## ADDENDUM NO. 1

**DATE: September 26, 2013**

Contract 13-C-00044; Howard F. Curren Gravity Thickener and Sludge Pump Replacement

W.O. 8  
SHEET  
6  
OF 14

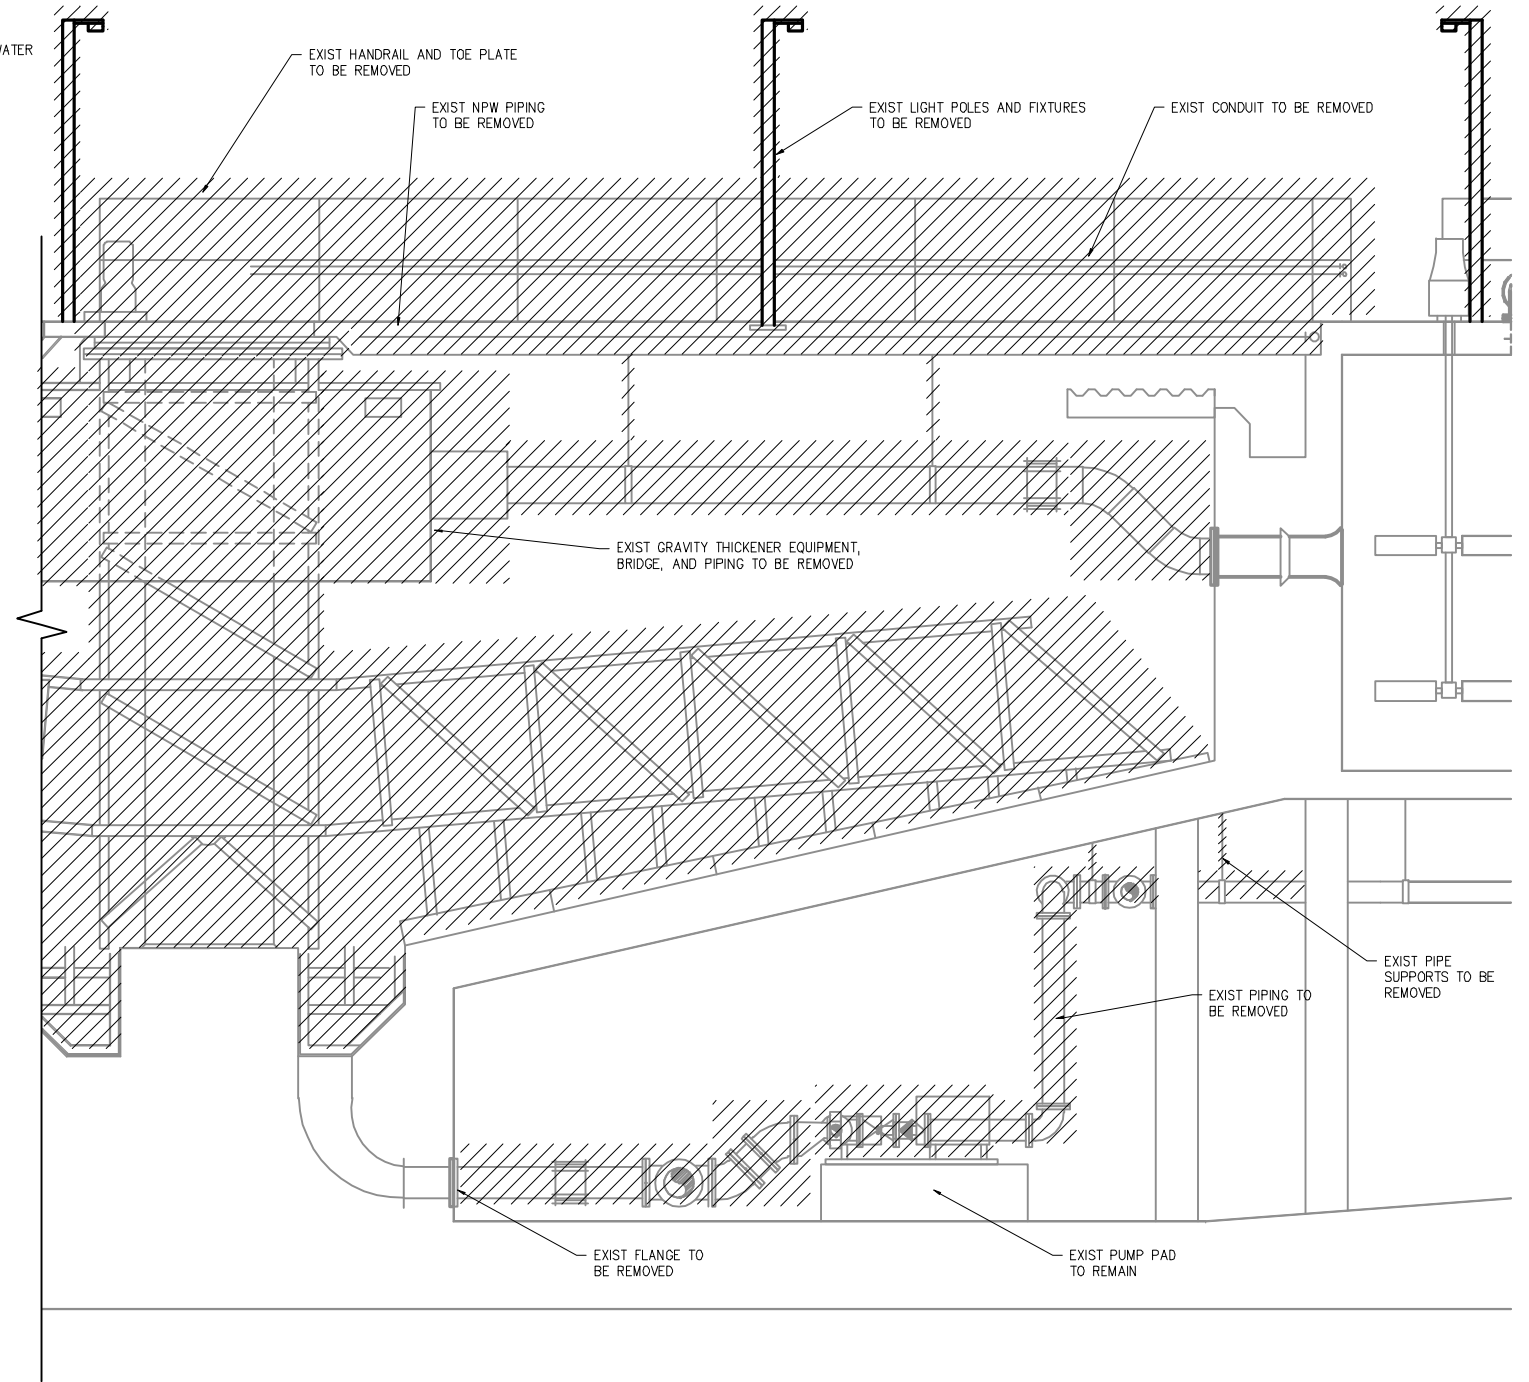
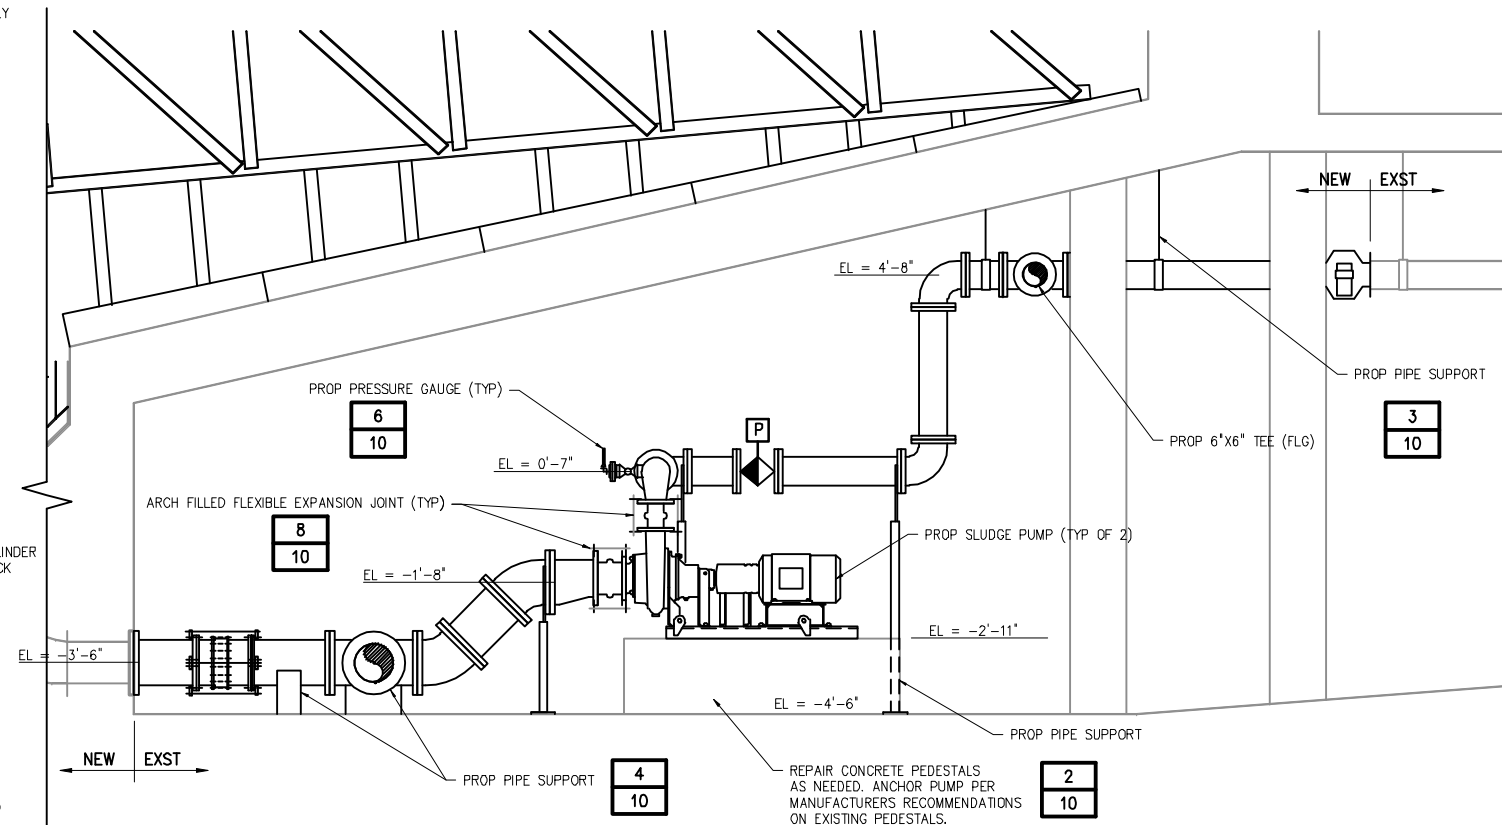
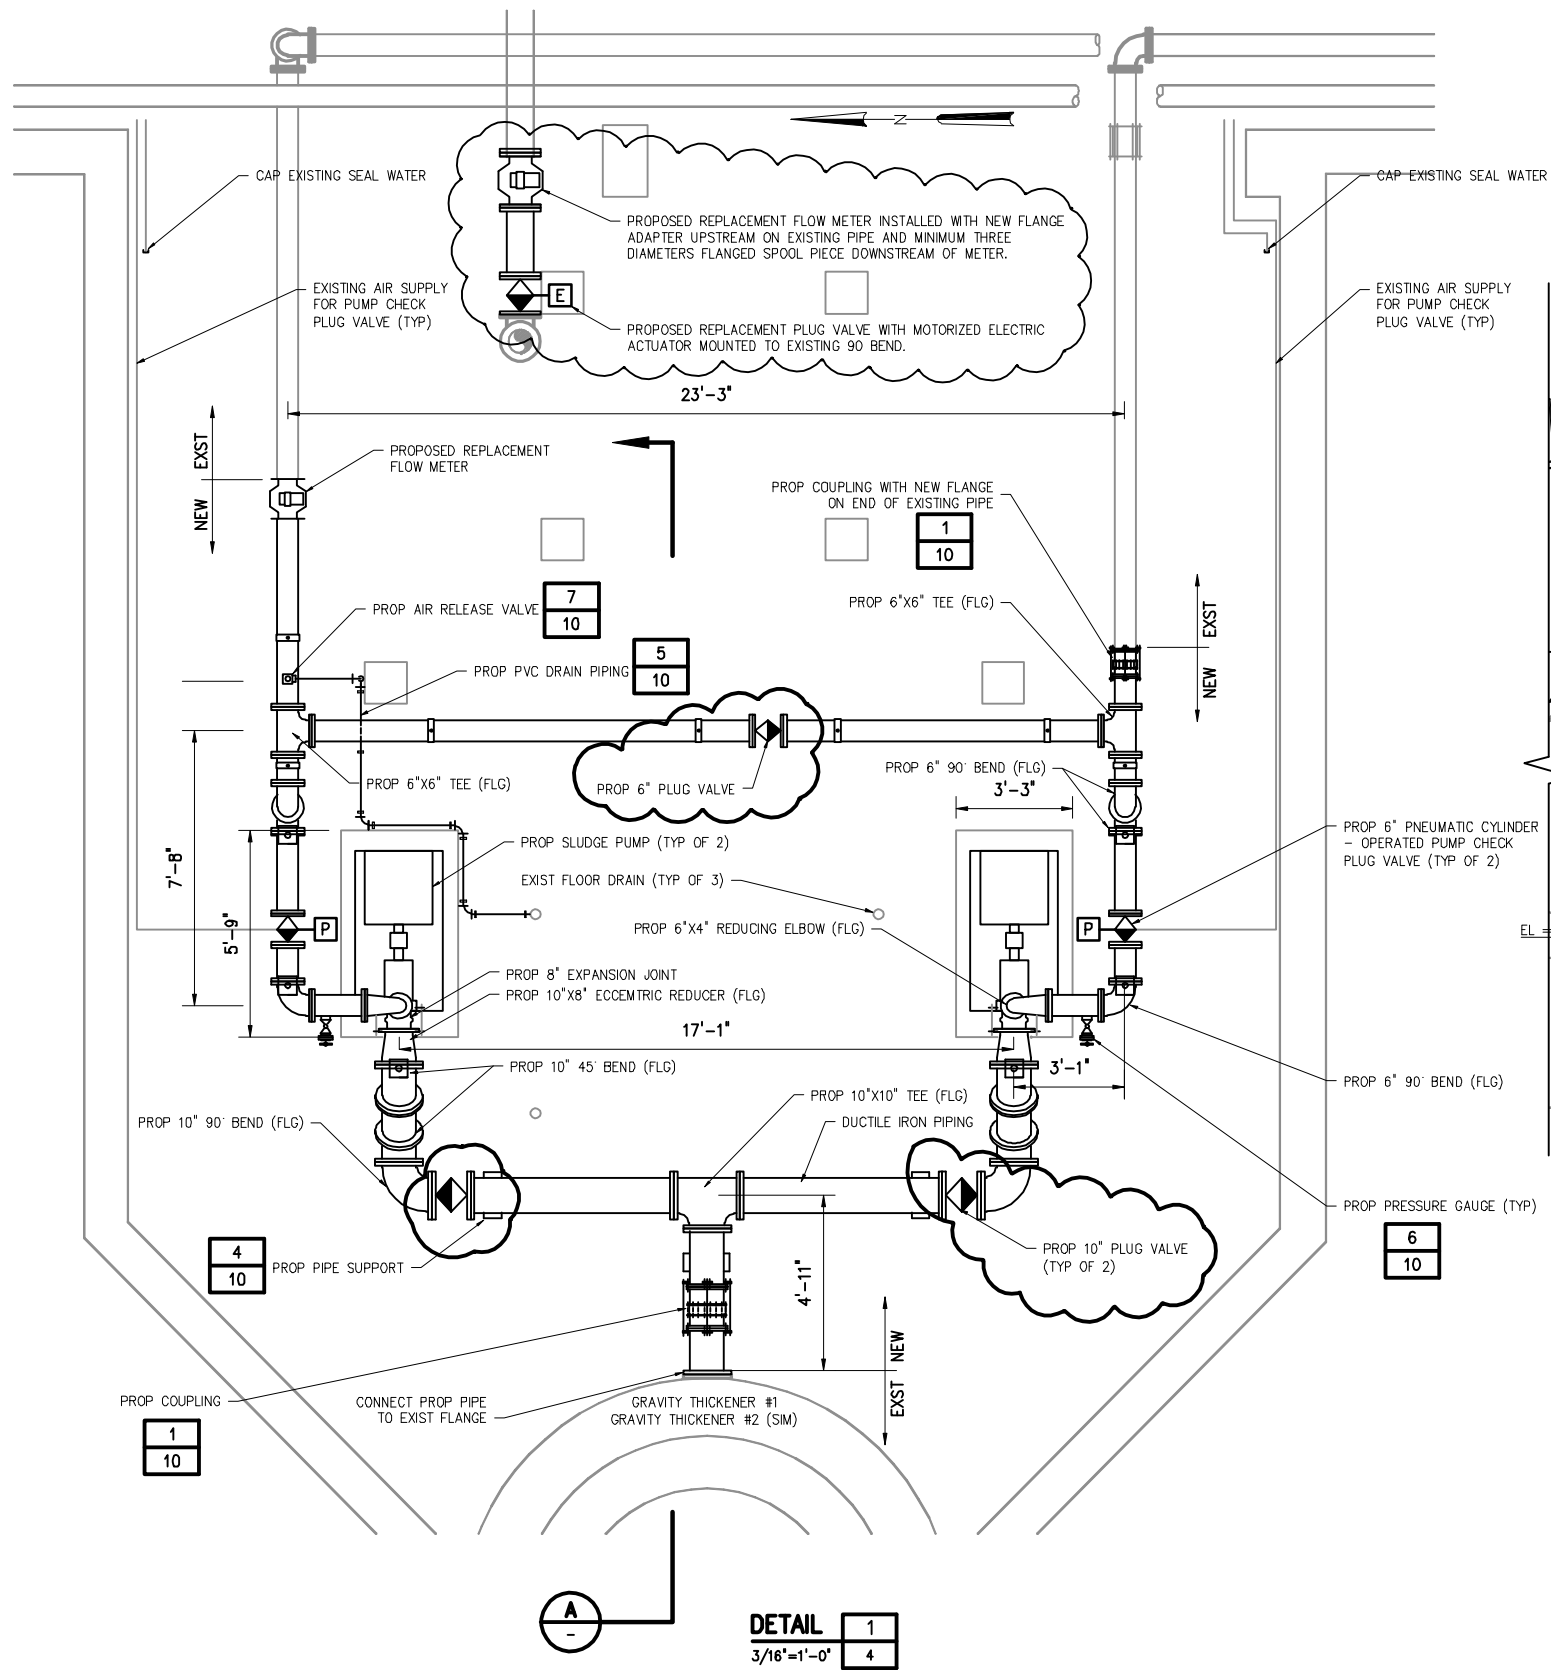
- Item 3: Replace Sheets 6, 7, and 13 with the attached updated drawings. Revisions in clouded area depict replacement of existing non-potable water flow meters and actuated valves. Flow meter is same as that specified under Section W-35 but is 8-inch in size. Valve and electric actuator are the same as that specified for plug valves under Section W-32 (for eccentric plug valve) and 15115 (for the actuator). Revisions also show eliminating the need to replace three existing valve position limit switches, cable, and conduit within each alcove area.

# GENERAL MACHINERY VIBRATION SEVERITY CHART

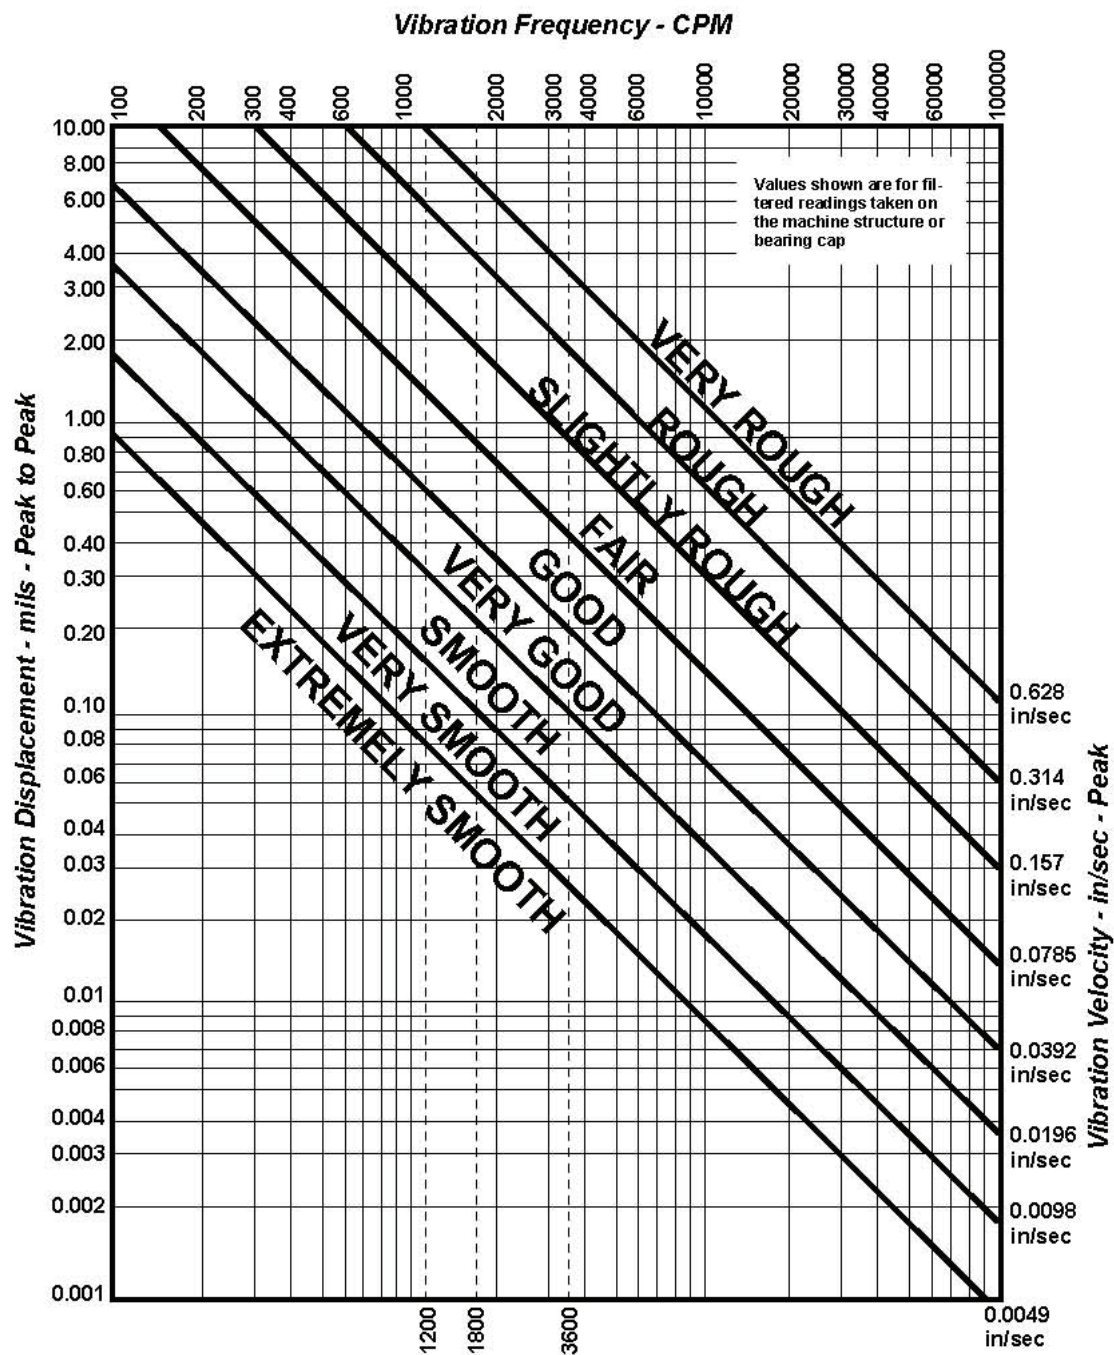
Item 10: Replace the existing Vibration Severity Chart located at the end of the Specific Provisions with the attached Vibration Severity Chart.
